8.2 **DA 2013/298 - Attached Dual Occupancy, Lennox Head.DOC**

Re: DA2013/298 – Proposed dual occupancy at 13 Dress Circle Drive,
Lennox Head

**RE: THIRD AMENDMENT TO DA 2013/298 – Applicant Mrs S.R. Crumlin & Mr K.D. Barron – Lot 20
DP: 29654**

PROPOSED STRATA DUAL OCCUPANCY 13 DRESS CIRCLE DVE LENNOX HEAD
 DATE: SEPT 2013 SCALE: 1:100(A3) ISSUE: C-DA/CC DWG No: DA-03

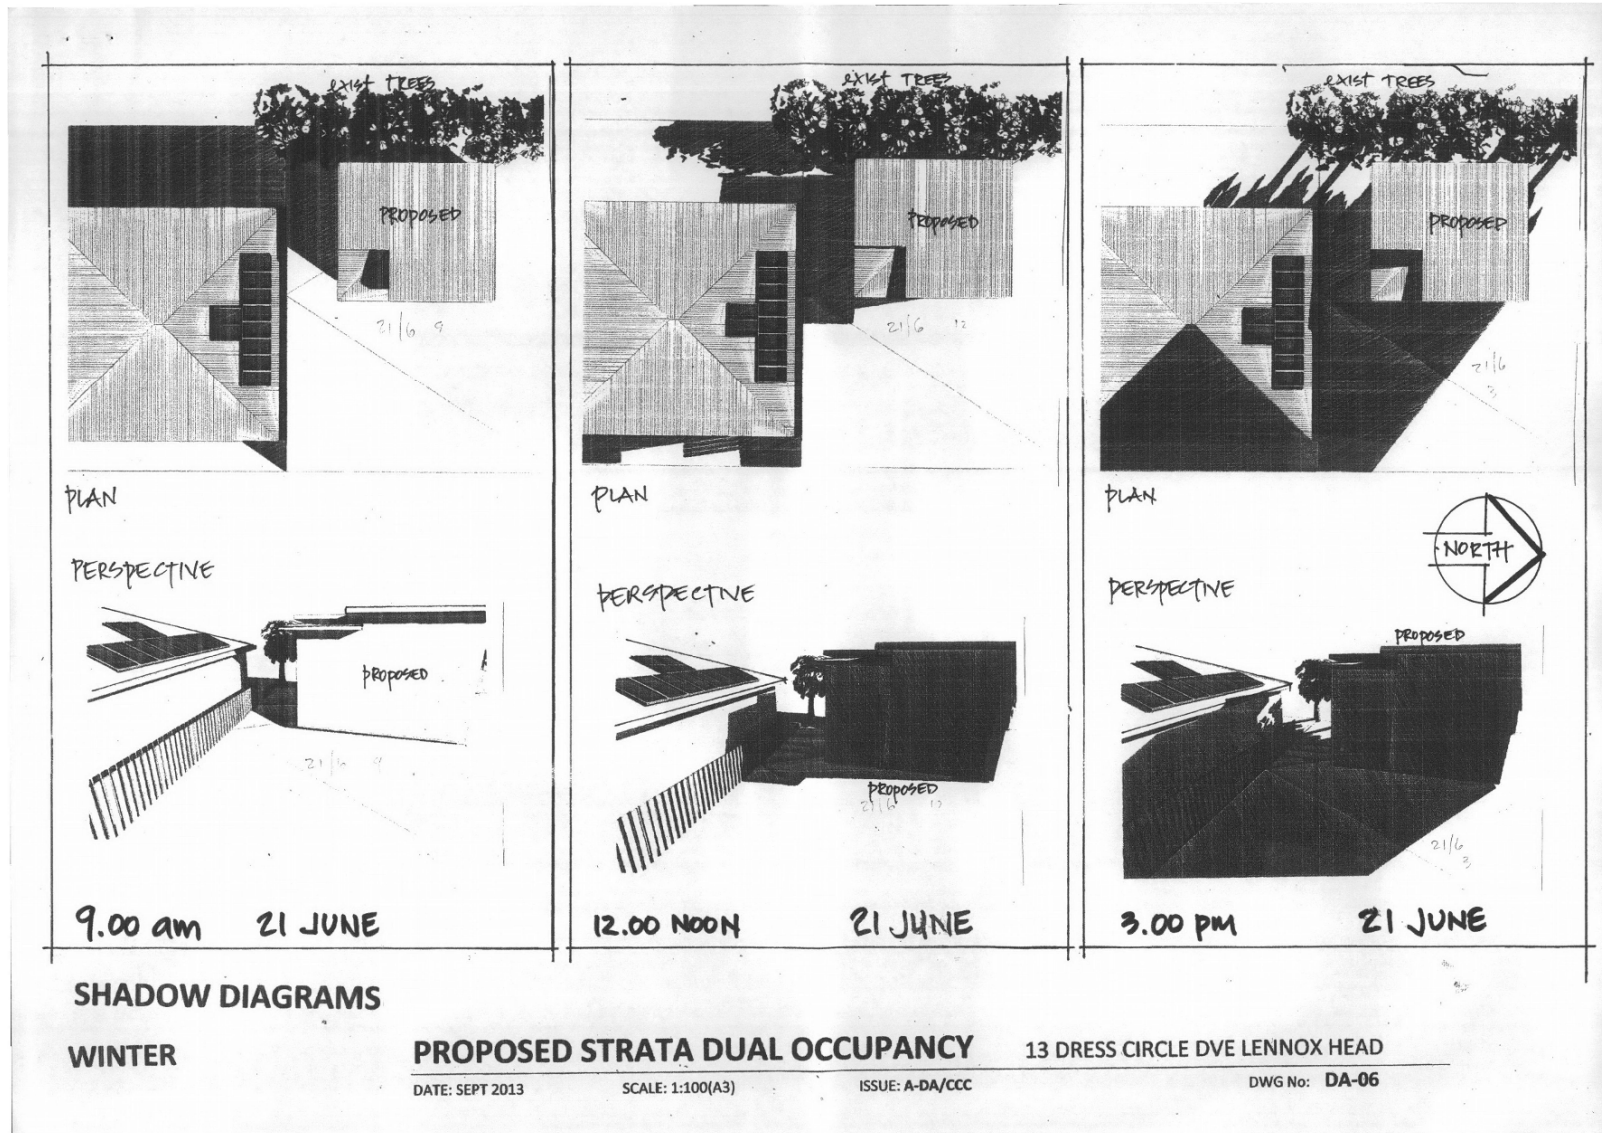
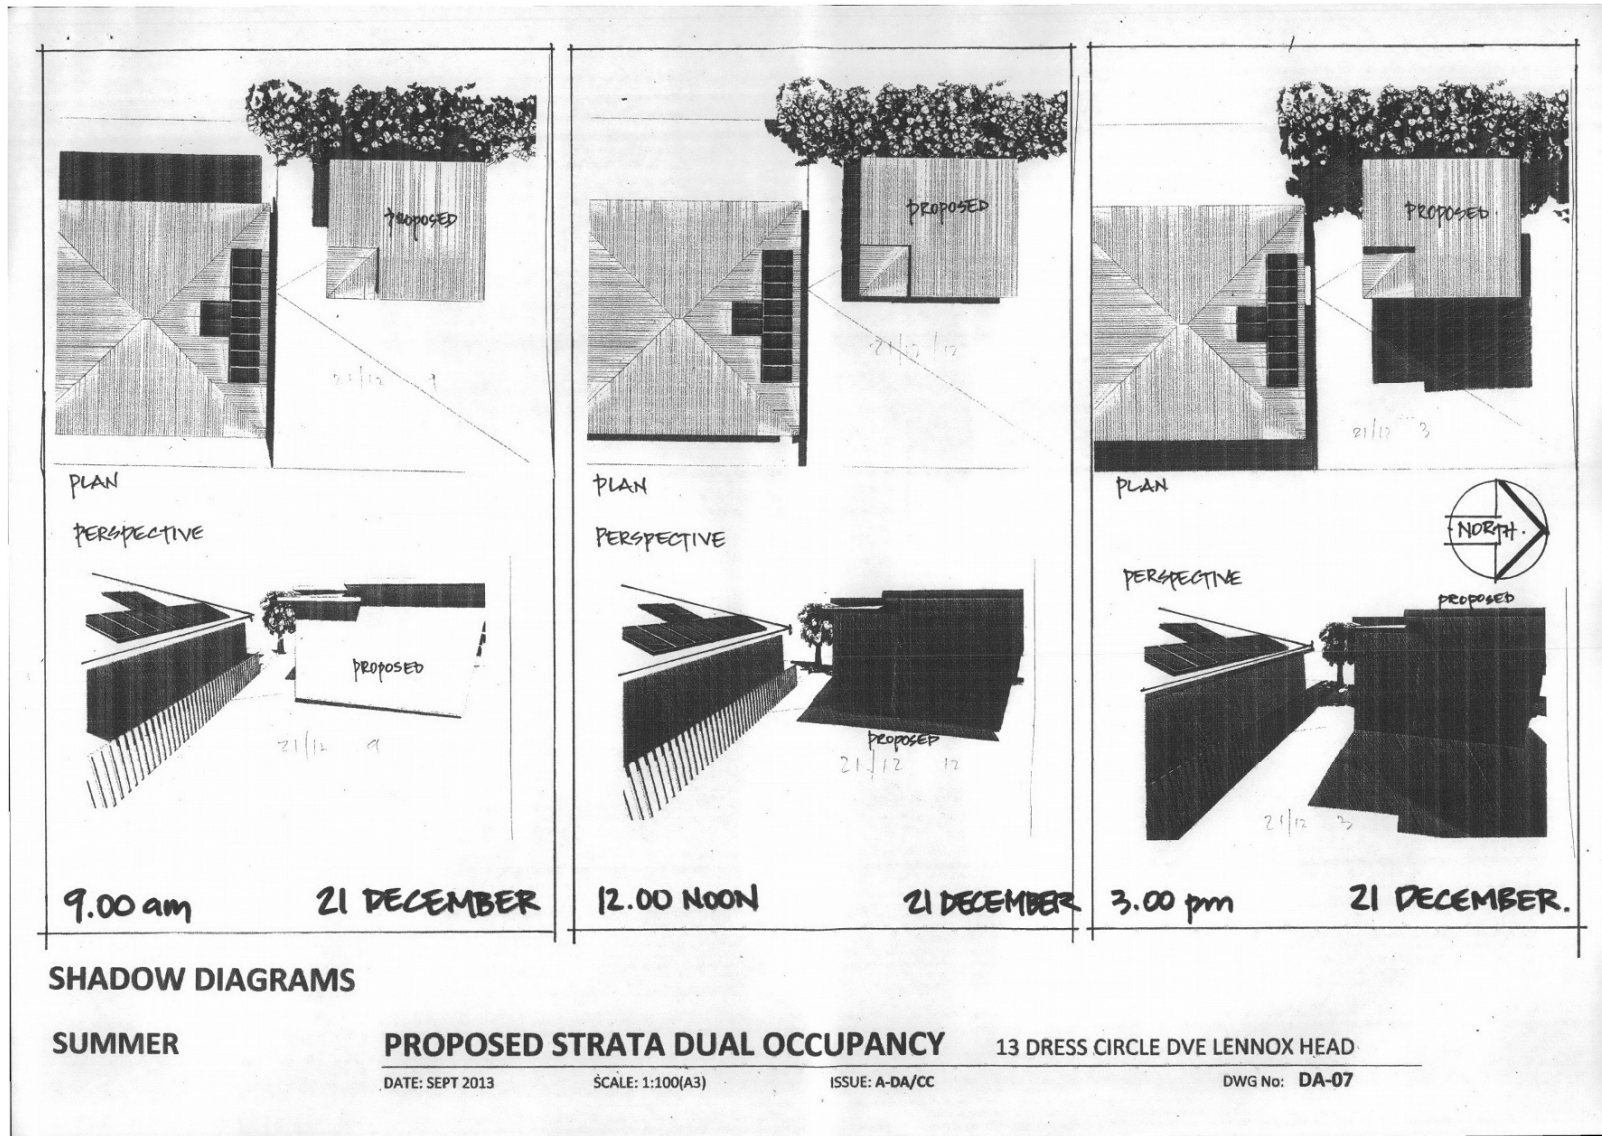
The ground line on your boundary, Elevation South, does not appear correct and over a metre lower at the eastern end of the proposed unit. This lowers the building hgt plane and makes more of the proposed unit non complying.

1 I could find no land level at the SE boundary corner of the subject land but assuming about RL8.5 then in my opinion the ground line is not drawn accurately on the application. From my calculations the natural ground line is about 1.3m below the ground line drawn on the applicant's south elevation at the SE corner of the proposed building work;

2 Once the ground line is drawn accurately the proposed unit does not comply with the building height plane on the SE corner. The proposal protrudes through the height plane by about 2.1m. The building height plane should be strictly adhered to, particularly on the south of the proposed building, to protect your solar access. It is the intention of Council's DCP building height plane to protect solar access to neighbours;

3 Another concern is the hedge planting which first appears on the elevations revision C. This hedge has the potential to cause the most overshadowing and could turn into what is called in the Land and Environment Courts a "spite hedge". To limit overshadowing of your property the species for this planting should be carefully selected to not exceed 2.5m at plant maturity.

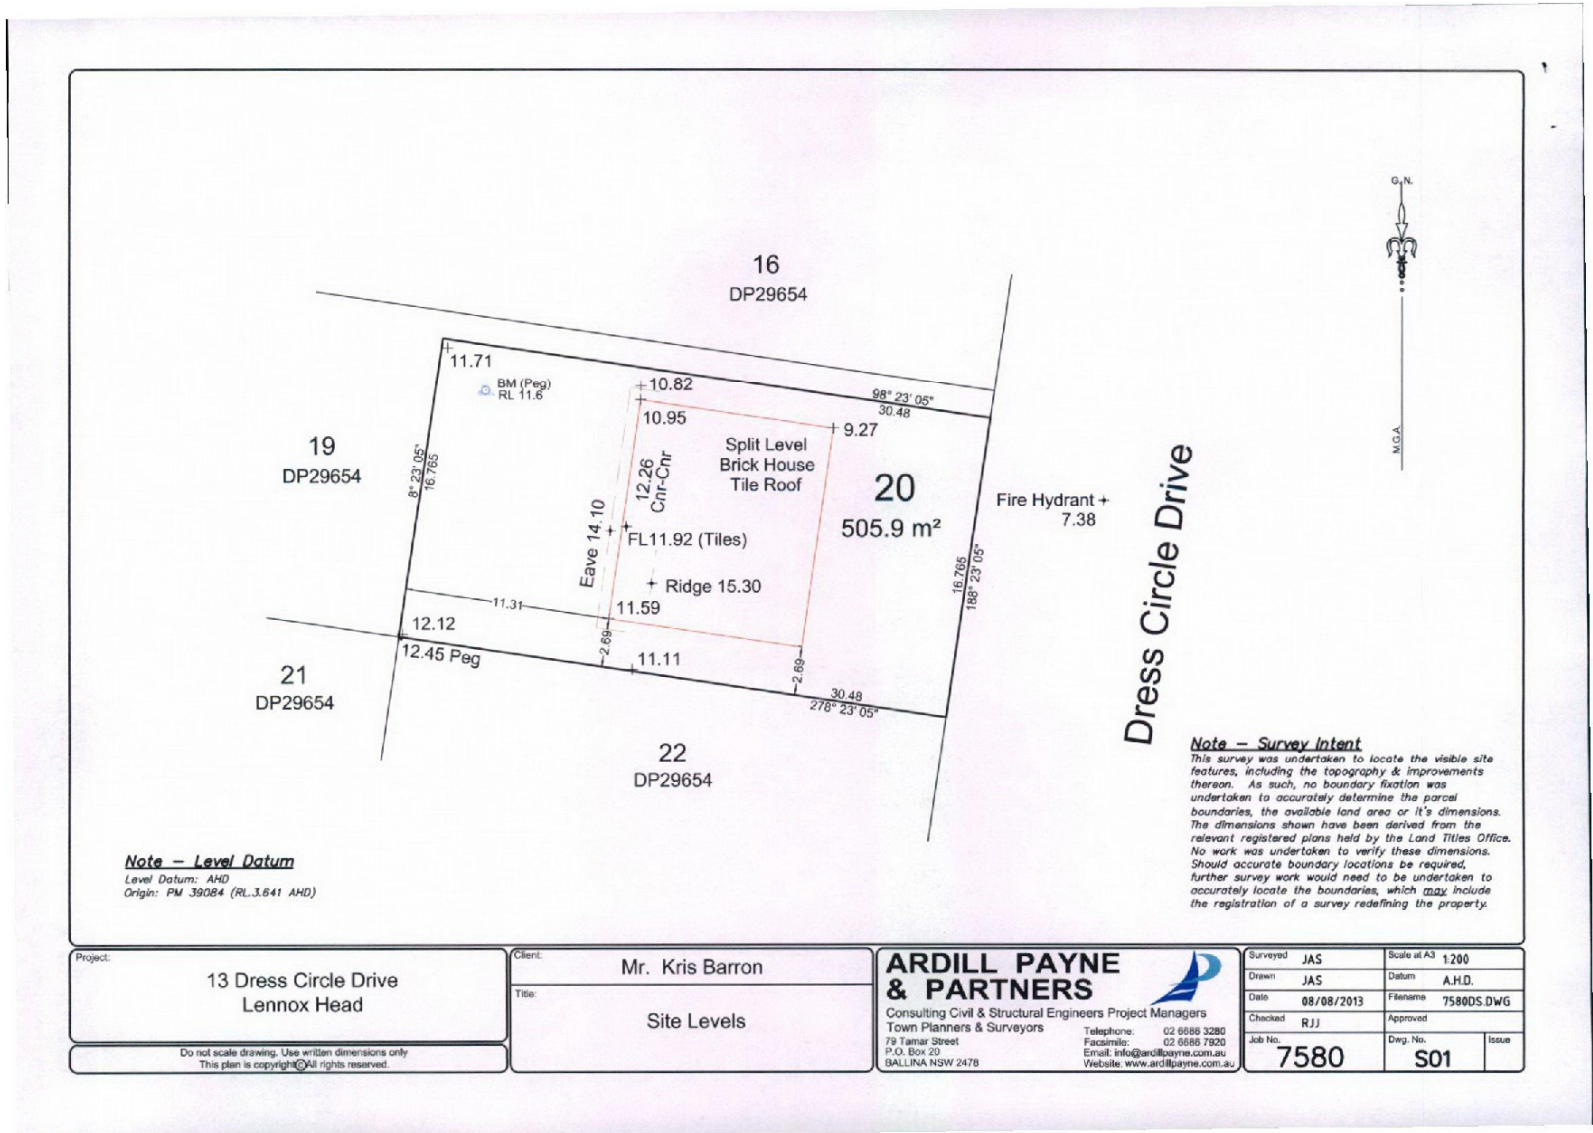
I refer to a detail survey previously done by an unknown surveyor, and in particular a level shown as 10.75 near the southwestern corner of the existing high set brick dwelling No. 13 (see attached sketch plan).

I have been on site and measured levels as shown in attached sketch plans "7580 S01" and "7580 S02" (see attached). By comparison, my levels closely match common positions and features shown on the original plan.

It is of my opinion, however, that the level shown as 10.75 shown on the previous plan does not reflect the current ground level near that location. Unless significant filling has occurred, the level is more approximately 11.75 and possibly could be a drafting error.

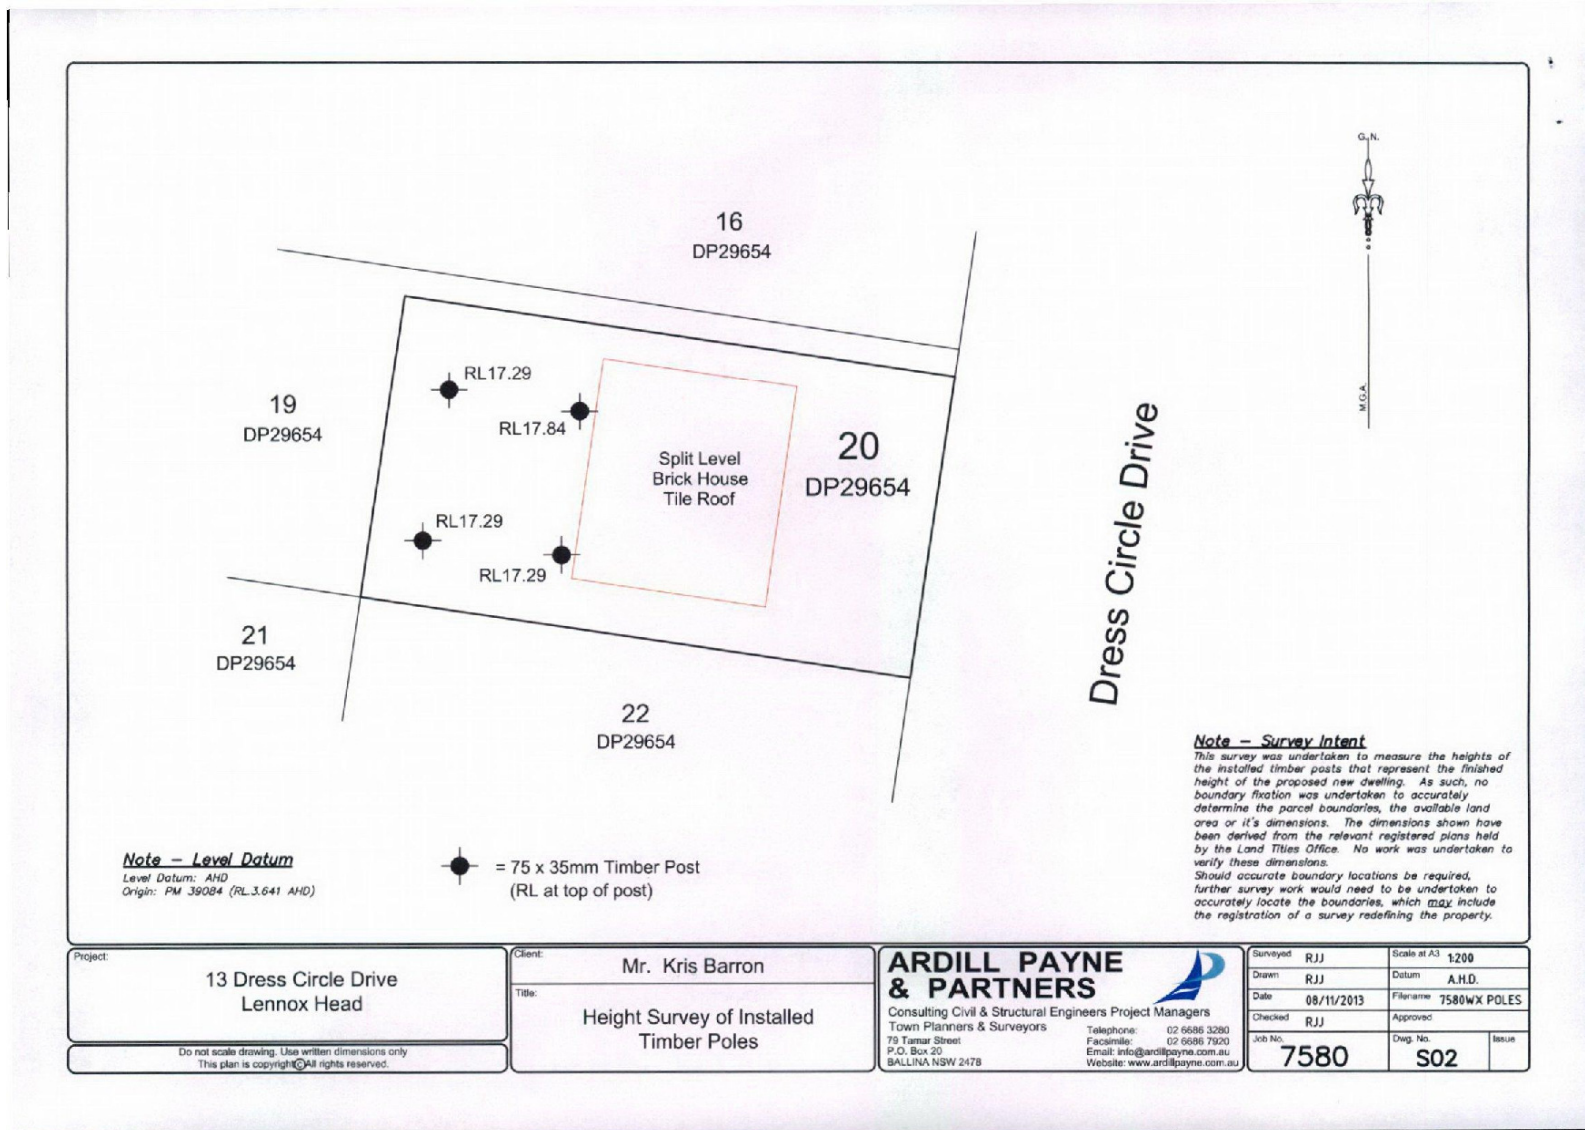
I have sketched on the north side of your house the effects at noon 21/6 (East Elevation). The shade would be up to about your first floor window sills when the sun is at 38deg. Summer is not so critical as the sun is about 85deg and almost overhead. From my sketch it appears your solar panels are outside the shadow zone at noon. As the day progresses the trees NW of your house would start shading your house/panels and the building becomes less critical.
